Hi-Performance MARINER OUTBOARDS
MERCURY PERFORMANCE OUTBOARDS

service bulletin

No. 98-12

Suppressor Type Spark Plugs Required with 849849A_ ECU

Recommended Spark Plug: NGK BUZHW (P/N 33-14103550)

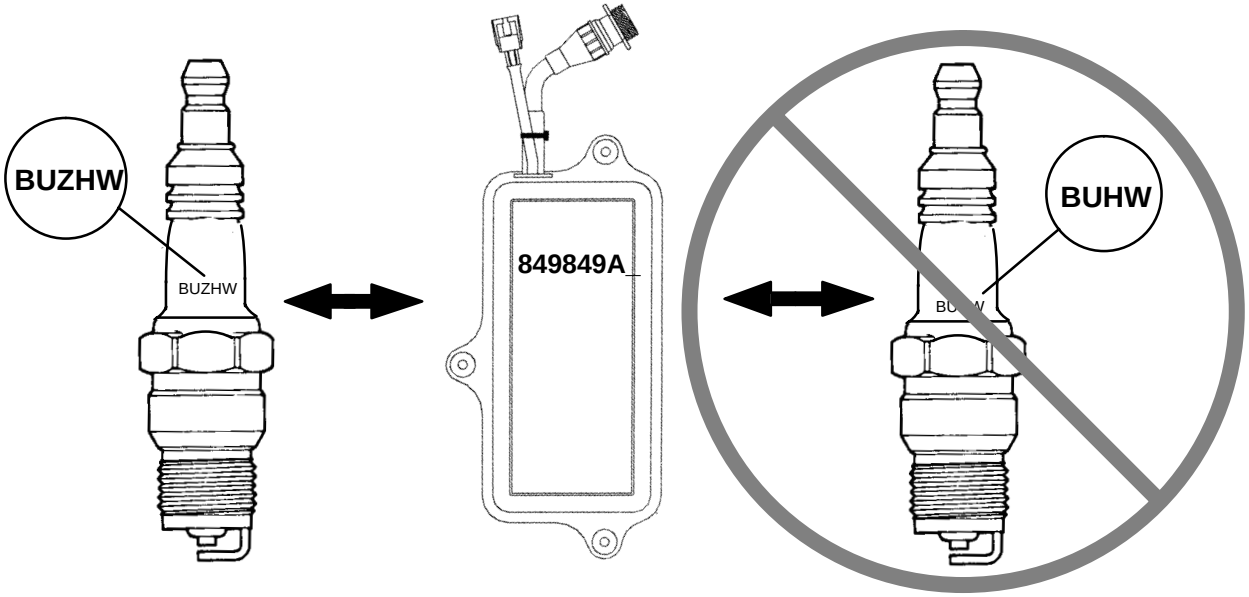
Any 2.4 or 2.5 EFI engine using a 849849A_ ECU should use a suppressor type spark plug to avoid poor engine running qualities and electrical interference with the ECU.
